CITY OF FISHERS AGENDA

BOARD/COMMISSION: Nickel Plate Review Committee Meeting

DATE: 4/26/2023, at 5:00 PM

Case Number: NPR-23-2

WEST FACADE

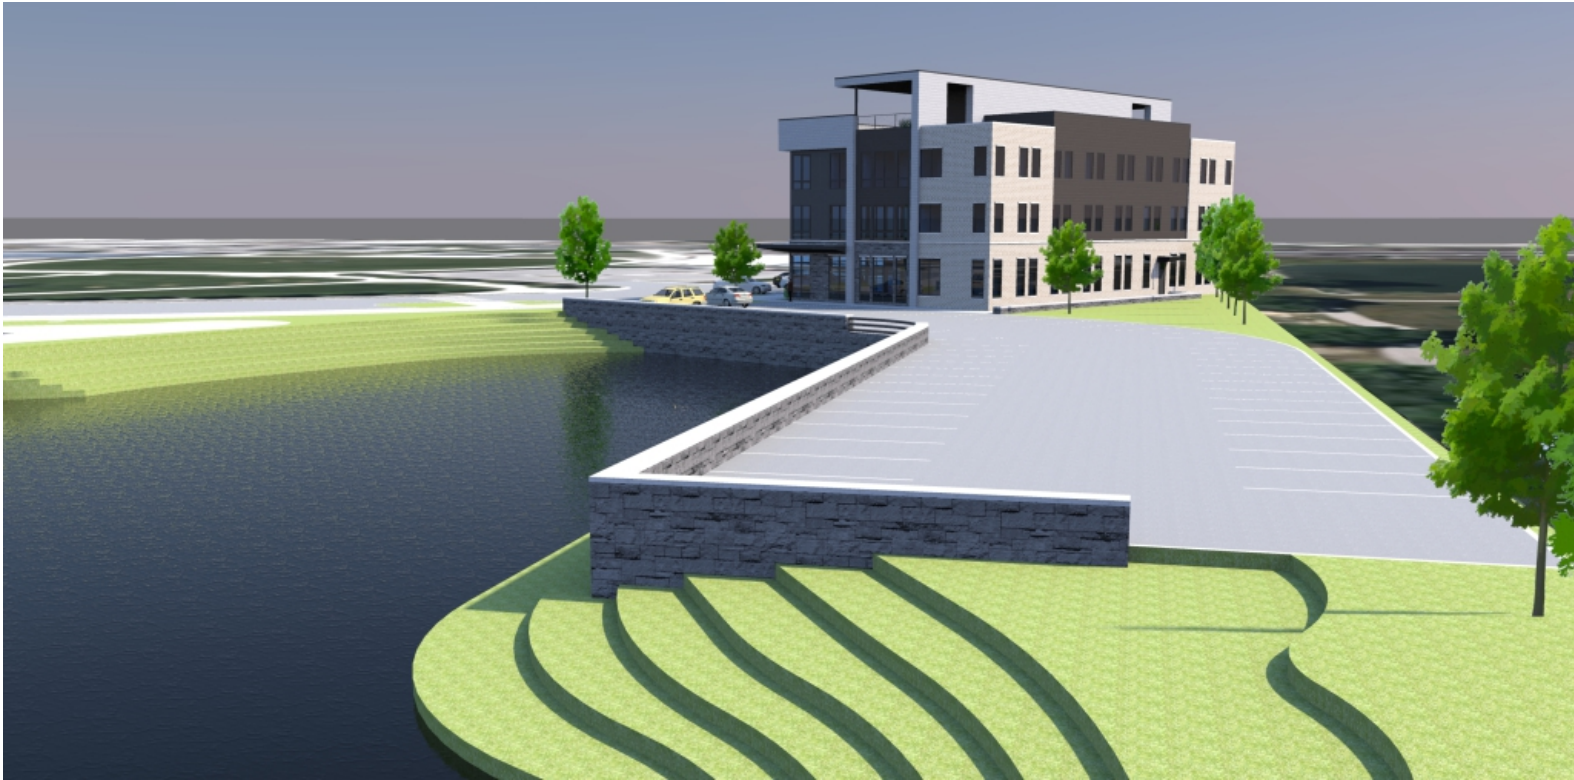
○ Mechanical & Utility Equipment Screening: HVAC will be located on the west side of the exposed roof, currently a proposed parapet wall is provided to screen. Two areas per the elevation (south and north) elevation are still exposed. If required for access, staff recommend a pedestrian gate to provide access and screening.

We believe the elevation can be simplified to reduce the amount of material and provide a single masonry product, such as the proposed brick in lieu of the brick veneer. The elevation vs the material samples does show how these materials are more complimentary vs. the elevations where they appear different. Seeing the materials in person may help guide the review committee to a decision. Either way, staff recommends that masonry is required along the entire ground floor, unless glass is being proposed.

1. All staff comments must be addressed and resolved with the Departments of Planning & Zoning, Engineering, Public Works, and Fire.
2. Masonry should be provided along the entire ground floor on all sides of the building.
3. The proposed awning be extending and wrap the northeast corner of the building, creating a defined corner and defined entrance.
4. HVAC Units are completed screened, either by a parapet wall or gate for access.
5. A Nickel Plate District corner stone is added to the façade adjacent to the right-of-way.
